**HIROSE ELECTRIC CO., LTD.**  
2-6-3 Nakagawa Chuoh, Tsuzuki-ku, Yokohama, JAPAN

**Product Change Notification**

## ■Product list PCN2022-16\_IX80G Series Adhesive Cap and Embossed Carrier Tape Shape Change

**■ Shape Change**

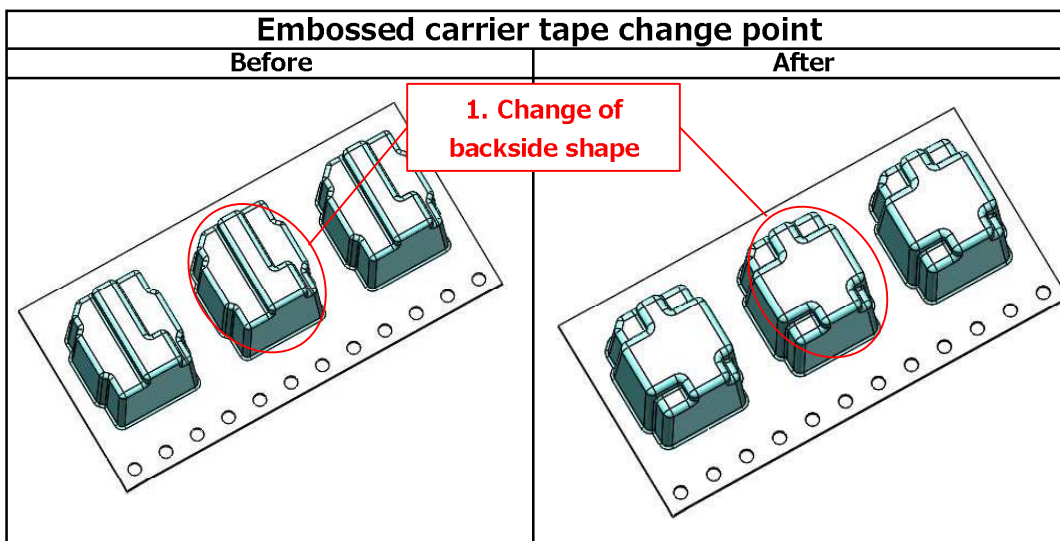
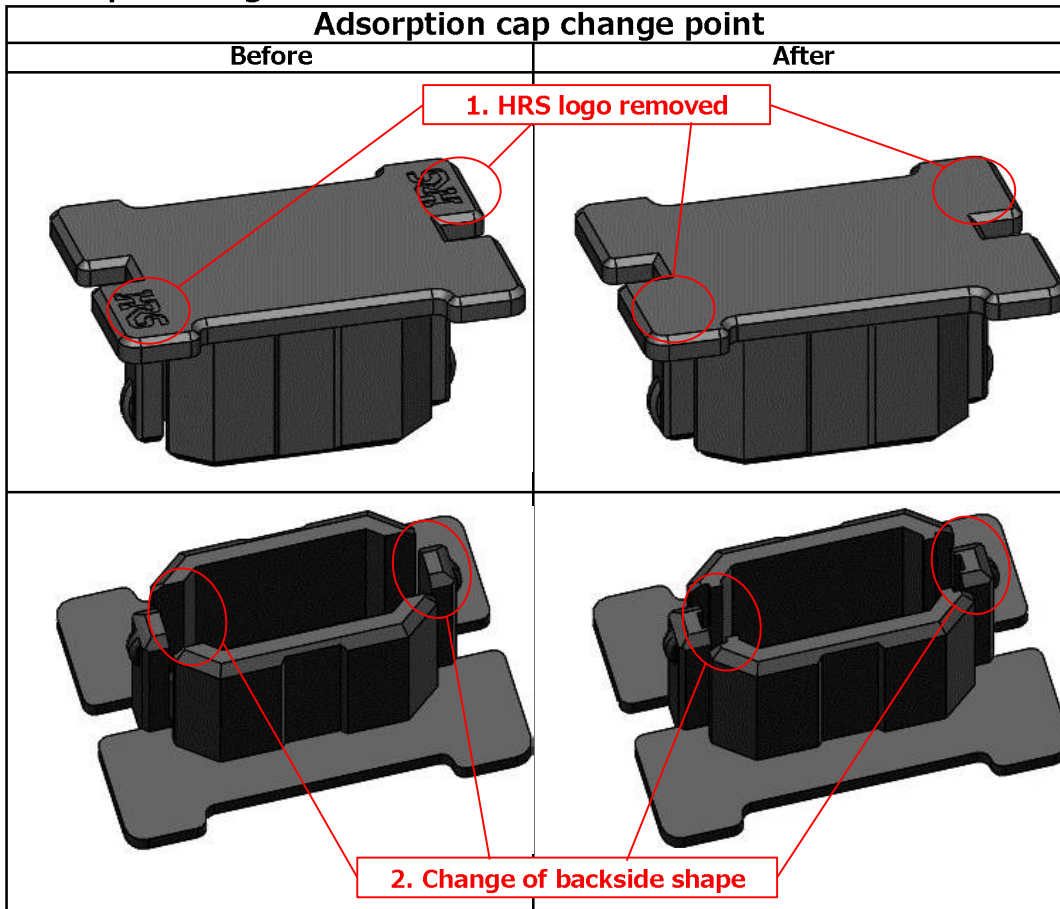
1	Products affected	IX80G Series *Please refer to the attachment 1 for detailed product names.
2	Replacement product	There is no change in product code and product name.
3	Classification of change	Product specification change.
4	Changes	The shape of the adsorption cap and embossed carrier tape will be changed. See attachment 2 for details. These changes will not affect the performances of the connector itself.
5	Reason for change	Shape will be changed to improve productivity.
6	Schedule of change	The switch will be made from production on June 30, 2023.
7	Date of your acknowledgement	By May 31,2023
